**Re: Hanna Region Transmission System Development**  
**Application No.: 1606434, Proceeding ID: 768**

**Re: Hanna Region Transmission System Development – Alberta Utilities Commission (“AUC”) Approval No. U2010-135 (“Hanna NID Approval”)  
Application No.: 1606434, Proceeding ID: 768**

1. The Alberta Electric System Operator (“AESO”) is writing to request that the AUC approve specific amendments to the Hanna NID Approval, issued by the AUC on April 29, 2010, as more particularly described below.

**812-SLD-768S**

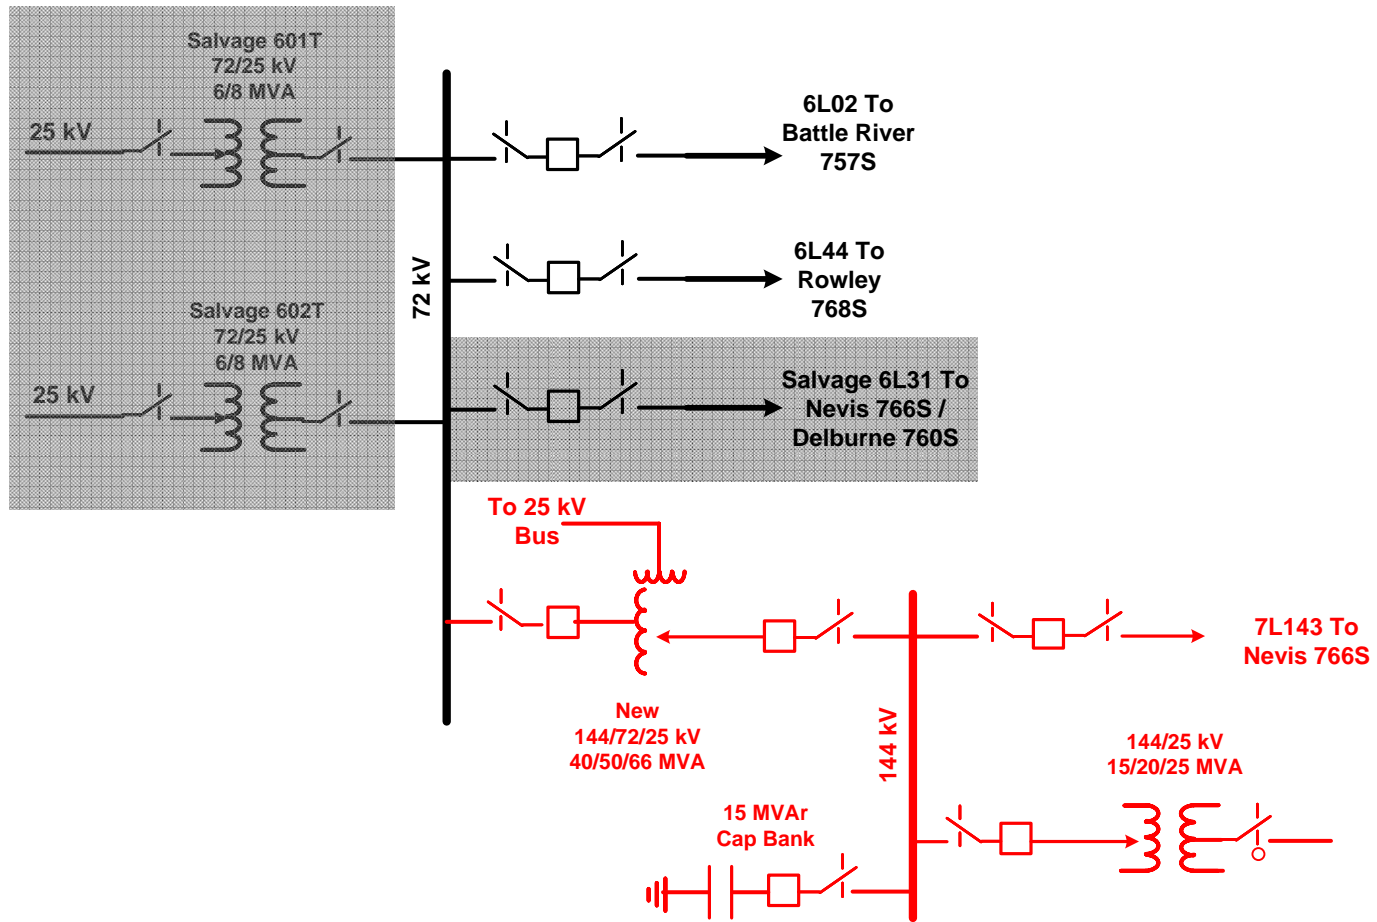
*“A new 144 kV Cornish Lake 954S substation replacing the existing Rowley 768S substation and connecting in-and-out on the existing 144 kV line 7L25.”<sup>4</sup>*

10. During the NID estimate phase, it was determined that there was not sufficient space to convert the existing Rowley substation to a 144 kV, or to connect in-and-out on the existing 144 kV line 7L25.

11. In the course of preparing its FA, which included a site visit by ATCO to the Rowley substation, ATCO determined that, in fact, there was sufficient space available to expand the Rowley 768S substation. As a result, construction of the 144 kV Cornish Lake 954S is no longer required.

(a) *Delete* paragraph 13 under **Stage I (Needs for 2012)**; and

*“Converting the existing 72 kV Rowley 768S to a 144 kV and in-and-out on 7L25.”*

**812-SLD-769S**

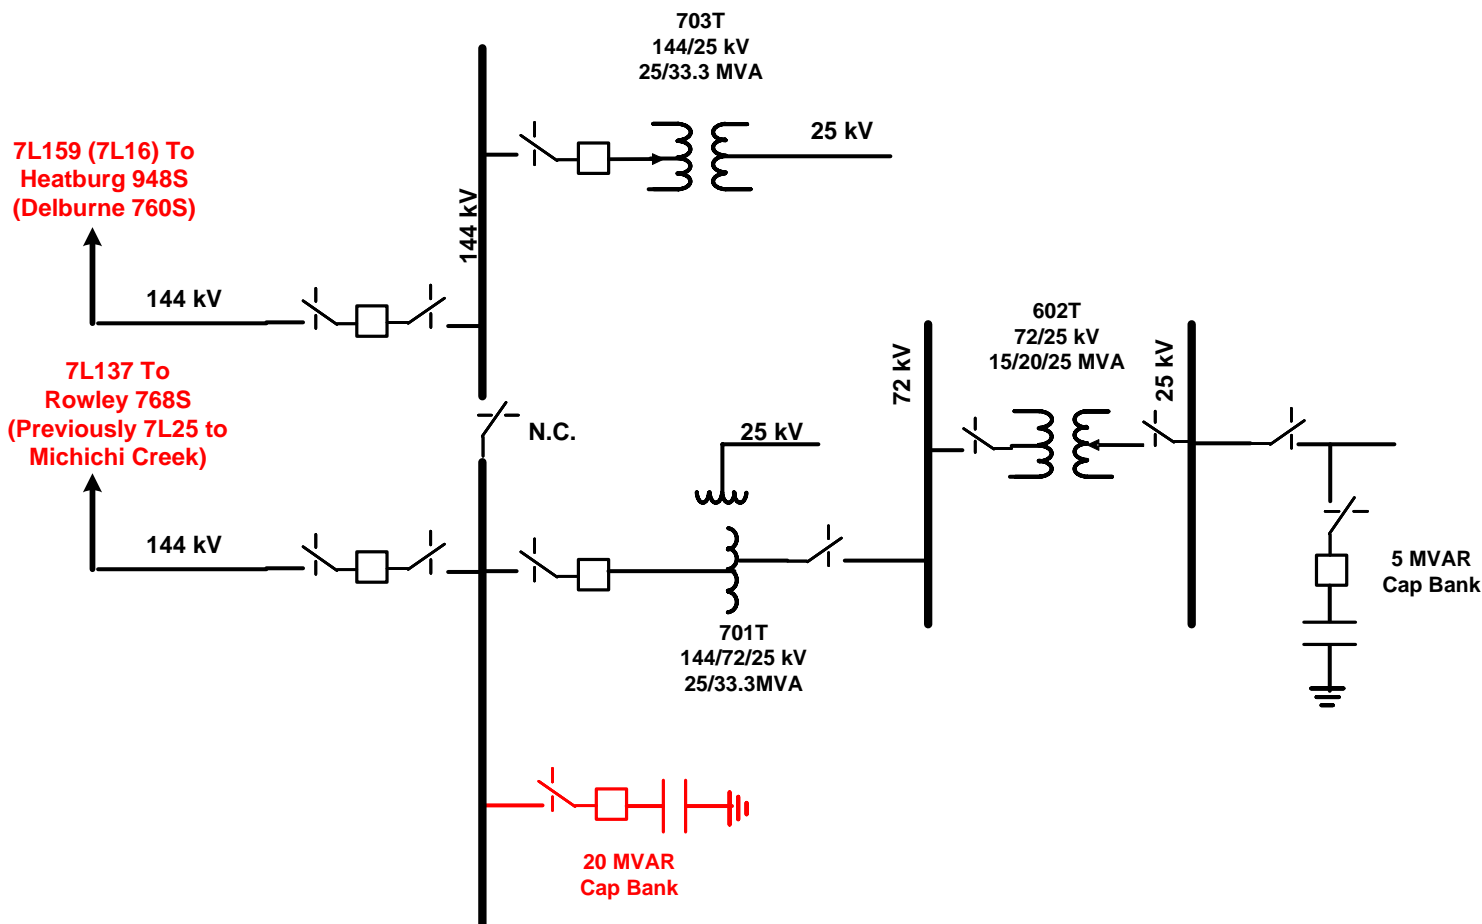
*“Converting the existing 72 kV Stettler 769S substation to a 144 kV and a new 144 kV line from Nevis 766S substation to Stettler 769S substation.”<sup>6</sup>*

16. As set out in Table 8-1 of the Hanna NID, conversion of the existing Stettler 769S substation contemplated the use of a 25 MVA 144/25 kV load transformer and a 33.3 MVA 144/72 kV tie transformer.
17. Given that the larger size transformers would be more useful for meeting the long term load growth in the area than the smaller transformers originally contemplated, the AESO is of the view that the larger transformers should be utilized.
18. Accordingly, the AESO respectfully requests that the AUC approve the following specific amendment to the Hanna NID approval:

20. In the Hanna NID application filed by the AESO with the AUC, the capacitor bank sizes were incorrectly described for the Three Hills 770S substation and the Stettler 769S substation in the text of the Hanna NID application and in Appendix “G”.

*“Converting the existing 72 kV Stettler 769S substation to a 144 kV substation, including a 144 72 kV – 40/50/66 MVA tie transformer and a new 144 kV line from Nevis 766S substation to Settler 769S substation.”*

812-SLD-770S

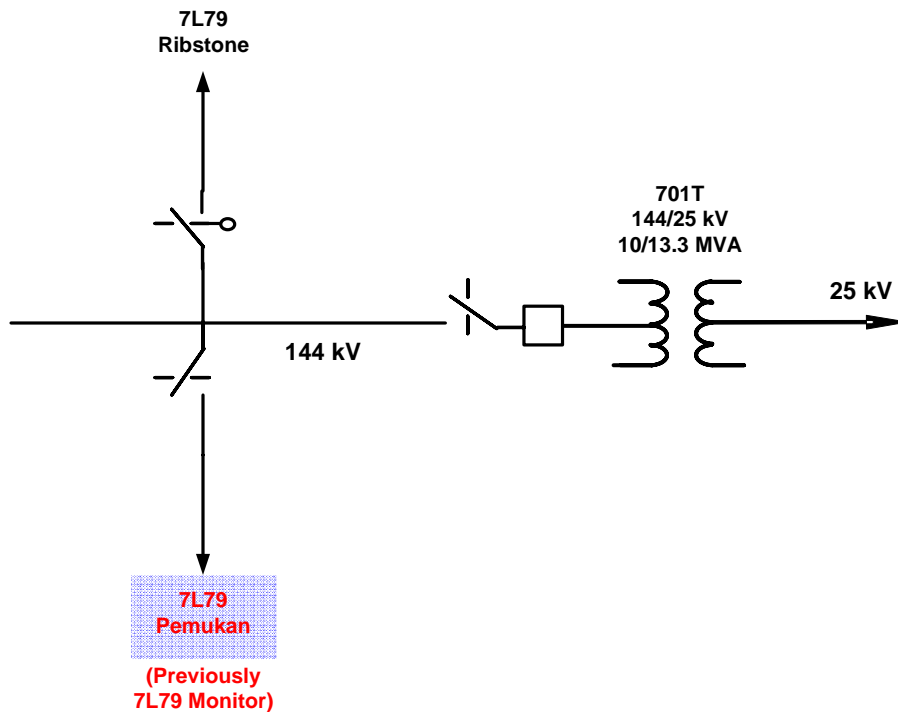
21. With respect to the Three Hills 770S substation, the incorrect references can be found at Page 67, Item I-17, Table 8-1 and on the single line diagram on Page 55 of Appendix “G”.
22. With respect to the Stettler 769S substation, the incorrect references can be found at Page 67, Item I-16, Table 8-1 and on the single line diagram on Page 54 of Appendix “G”.
23. It bears noting that system performance will be unaffected by these proposed minor changes.
24. Accordingly, the AESO respectfully requests that the AUC approve the following specific amendment to the Hanna NID approval:

*“One new 27-MVAR, 138 kV capacitor bank at Hardisty 377S substation; Two new 30-MVAR, 144 kV capacitor banks at Pemukan 932S substation; Two new 30 MVAR, 144 kV capacitor banks at Lanfine 959S substation; **One new 20 MVAR, 144 kV capacitor bank at Three Hills 770s substation; One new 15 MVAR, 144 kV capacitor bank at Stettler 769S substation; One new 5 MVAR, 72 kV capacitor bank at Youngstown 772S substation; One new 10 MVAR, 72 kV capacitor bank at Battle river 757S substation.**”*

**812-SLD-932S**

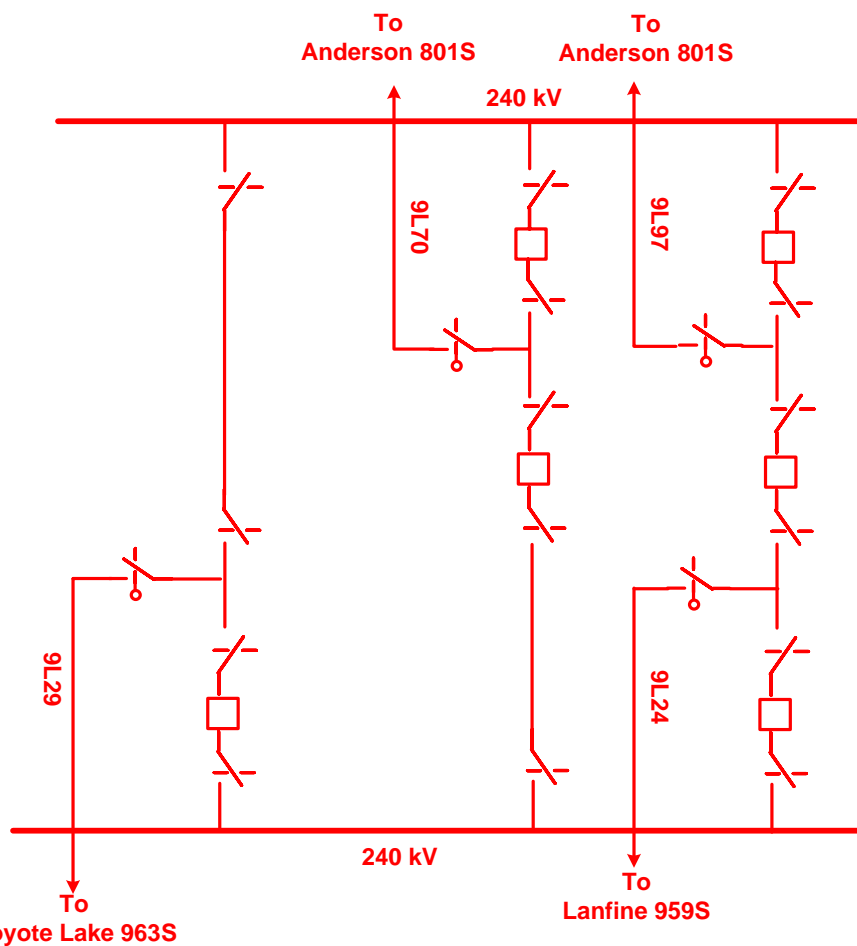
28. Specifically, the AESO has concluded that:
  - (a) SVCs for Stage 1 are required at Hansman Lake 650S substation and Lanfine 959S substation, but *not* at Pemukan 932S substation;

33. The Original Stage I SVC at Pemukan Substation is not required for the Stage I development. The AESO will consider whether it is required post – 2012, and if so, will seek such further amendment(s) to the Hanna NID Approval as may be necessary in relation to Stage II development (Needs for 2017)<sup>10</sup>.

*“Two –100/+200 MVAR, 244kV Static VAR compensators (SVC), each at Hansman Lake 650S substation and Lanfine 959S substation.”*

812-SLD-959S

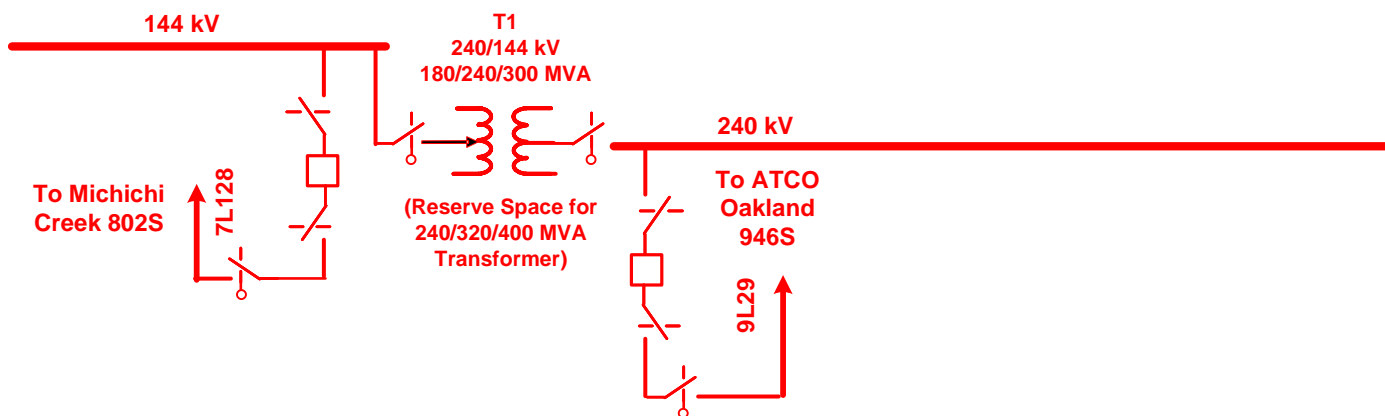
- (b) the appropriate size for the two (2) Stage I SVCs at these locations is – 100/+200 MVAR; and
  - (c) these SVCs should be installed on the 240 kV bus at both locations, and not on the 138 kV or 144 kV bus (“Revised Stage I SVCs”).
